WARRANTY BULLETIN #72/01

RE: RECALL A-140
1972 MGB & MGB-GT
SR# 258001 to 264748

NO. 72 Z 1

Glove Box Lock/Striker
Recall #A.140

MGB GLOVE BOX LID LOCK & STRIKER

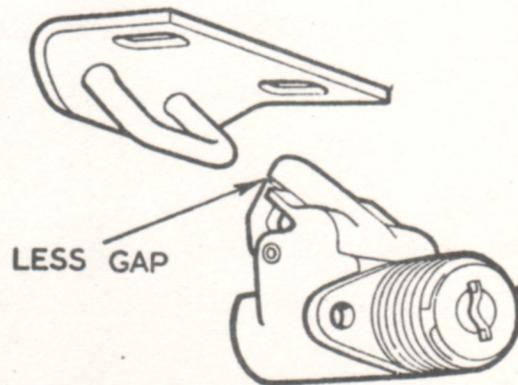
1. Examine the lock and striker assembly and compare with the following illustration.

B OLD TYPE

A NEW TYPE

If type 'A' is fitted, affix label Campaign #A.140 (supplied with this Bulletin), marked "Checked O.K.", to the inside of the glove box lid.

2. If type 'B' is fitted, it must be changed as follows:
 - a. Remove the lid stay retaining screw from inside the glove box lid.
 - b. Open lid fully and drill out the pop rivet heads that secure the lock to the lid (using a $\frac{1}{4}$ " drill).

- c. Unscrew the bezel from the lock barrel and withdraw the assembly from the lid.
 - d. Split the inner and outer panels of the lid by removing the four Phillips screws and carefully punch out the remains of the rivets. (Caution the inner and outer panels are riveted at their base, do not overstrain.)

- e. Install the new lock, rivet into place and reassemble the two panels.
 - f. Remove the striker and fit the modified part along with one spacer shim.

- g. By closing the lid determine whether the striker height is correct and adjust if necessary by adding or removing shims.
 - h. Adjust the striker by means of the slotted holes to make the lid fit flush with the fascia and resecure the stay.
